# Access Compliance Report
# Public Rights-of-Way
# (Curb Ramps)

| **Intersection ID: 21514** | **Main Street: E_ARROWOOD_RD** | **Cross Street: NATIONS_FORD_RD** | **Location: NW** |
| **ADA ID: 075485FD92CD** | **Ramp Type: BlendTrans1** | **Initial Pass/Fail: Pass** | **Overall Compliance: No** **Severity Score: 5** |

## Field Measurements/Component Compliance

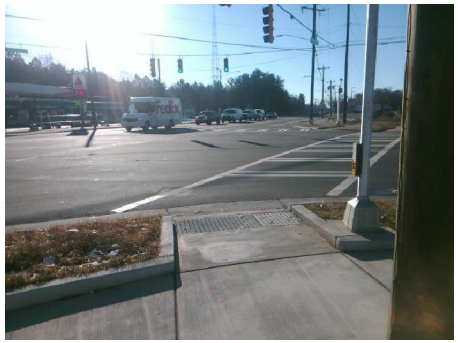
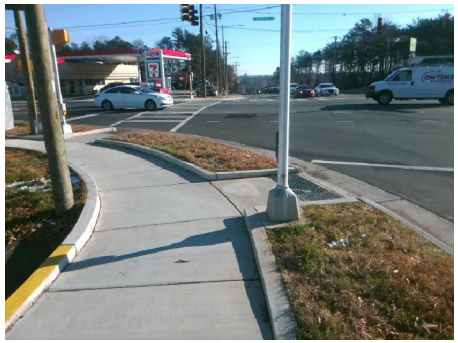
**Not Found, R305.2, R304.5.4**

| Compliance | Description | Data | Compliance | Description | Data |
|---|---|---|---|---|---|
| N/A | Landing Curb? (Y/N) | Yes | No | DWS Offset (in) | 2.5 |
| Yes | Gutter Ponding? | No | No | Gutter Slope (%) | 5.1 |
| | | | No | Curb Slope (%) | 8.4 |

**Remove & Replace Curb Ramp With Two New Directional Ramps or Equivalent. Remove & Replace Gutter.**
